## Dublin Area Train and Tram Services Map Suggested Map Edits

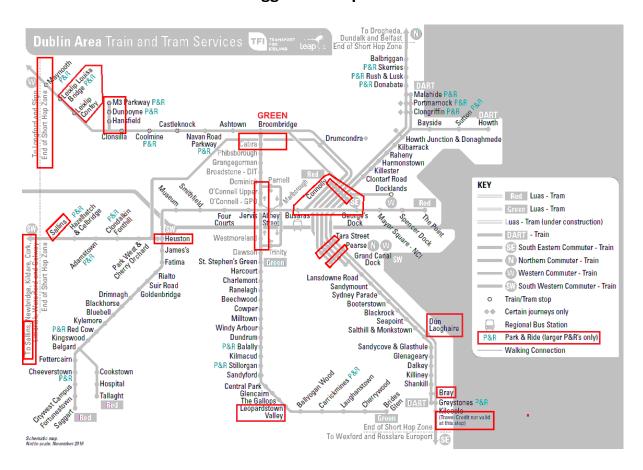
- 1. Kilcock will be added to the Short Hop Zone during 2017 space needed on map.
- 2. When Luas Cross City opens (end 2017), add "Green" 'box' at Broombridge.

- 3. Clonsilla to M3 Parkway could do with the direction of traffic being better indicated (M3 Parkway to city, never M3 Parkway to Maynooth) increase radius of curve and see the way that Y-junctions are shown on London Underground map <a href="http://content.tfl.gov.uk/standard-tube-map.pdf">http://content.tfl.gov.uk/standard-tube-map.pdf</a> The Clonsilla junction could be shown as being at Clonsilla.

- 4. Adding vertical space between Hansfield and Clonsilla may also be useful, as the stations from Coolmine to Broombridge could then be moved to the left.

- 5. It might be useful to show extra space between Cabra and Broombridge. Note that Broombridge is further west than Heuston and the line from Heuston to Connolly does not pass Broombridge.

- 6. "Sallins" is officially "Sallins & Naas".
- 7. "Leixlip Confey" and "Leixlip Louisa Bridge" are officially "Leixlip (Confey)" and "Leixlip (Louisa Bridge)" respectively.

- "Bray" and "Dún Laoghaire" are officially "Bray (Daly)" and "Dun Laoghaire (Mallin)" respectively.
- 9. Line-wrapping "Leopardstown Valley" and "Dún Laoghaire" seems unconventional someone might think there is a stop called "Valley". Not such a problem with double-barrelled names.

- 10. "To Sallins, Newbridge ..." delete Sallins from this list as Sallins is now on map. Consider including Tralee and Westport to list.

- 11. How should the dual names Heuston Station / Heuston and Connolly Station / Connolly be handled? While the existing isn't bad, it might be useful to emphasise these locations.

- 12. Should the walking distance for O'Connell GPO to Abbey Street to Marlborough be indicated (100 metres each leg, 200 metres total)?
- 13. George's Dock & Connolly and Busáras & Connolly are within walking distance of each other. It may be useful to show these as a walking connection, as westbound passengers will find it as easy to walk to Connolly from George's Dock as it is from Busáras (slightly longer walk, but quicker and no major street to cross) and evening Luas services do not serve Connolly.

- 14. On Luas Cross City, the presumed dominant flow will be from Broombridge to Sandyford and back, not Parnell to Sandyford and back (such service may operate at times). The junction curves should reflect this. Alternatively, show a three-way curve at O'Connell Upper-Dominick-Parnell.

- 15. Kilcoole "Travel Credit not valid at this stop" this may be confusing, as people may not understand it refers to Leap Card.
- 16. "Park & Ride (larger P&R's only)" what is the criteria for "larger", what of Clontarf Road, Booterstown, Sallins & Naas, Tallaght, Fortunestown, etc.?

- 17. Ideally, all names should be readable from the bottom or the right edge. Some, e.g. Museum, Smithfield are not, although it is difficult to see how this could be corrected.

- 18. Can Connolly, Tara Street and Pearse (and other interchanges) be shown more simply, e.g. a single oval?
- 19. Sandyford has a different stop icon to other stops.

- 20. Reverse order of Western Commuter and South Western Commuter from Tara Street to west of Drumcondra. This would allow Tara Street be shown horizontally, next to the Liffey.

- 21. While geophysically incorrect, show the Docklands line on top of the other lines (like the Luas Red Line is shown above those lines). Current layout makes it harder to read.

- 22. Where lines cross each other of the Liffey, the line is bolded. Is this necessary? It looks off at some scales / resolutions at Abbey Street, Tara Street to Connolly and Heuston.
